DESIGN/DEVELOPMENT REVIEW COMMISSION
DESIGN REVIEW DISTRICT
EVALUATION SHEET
Case #

ADDRESS: 1401 Hampton Street

NATURE OF REQUEST: Request for Certificate of Design Approval for repairs and renovations to existing buildings.

Sheet 1

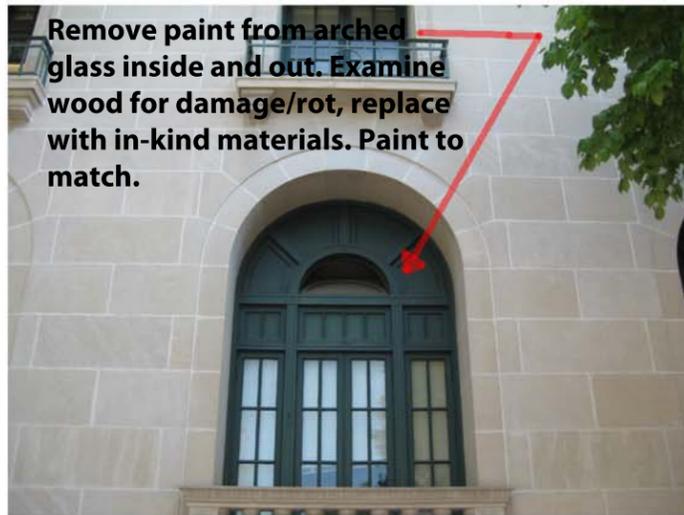
Remove paint from arched glass inside and out. Examine wood for damage/rot, replace with in-kind materials. Paint to match.

Sheet 2

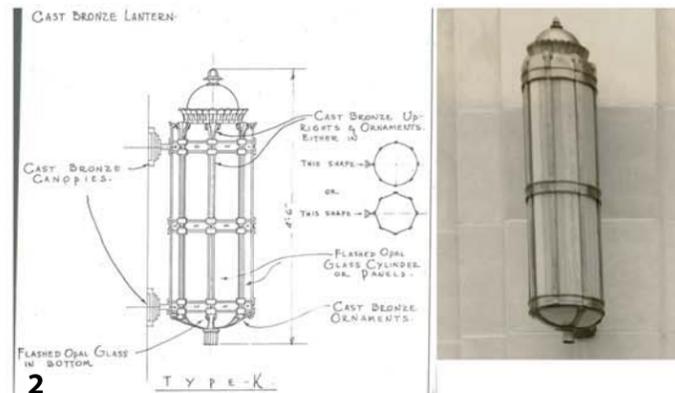
Existing light fixture to be removed and replaced with replica historic fixture.

Existing canopy to remain, paint to match existing color.
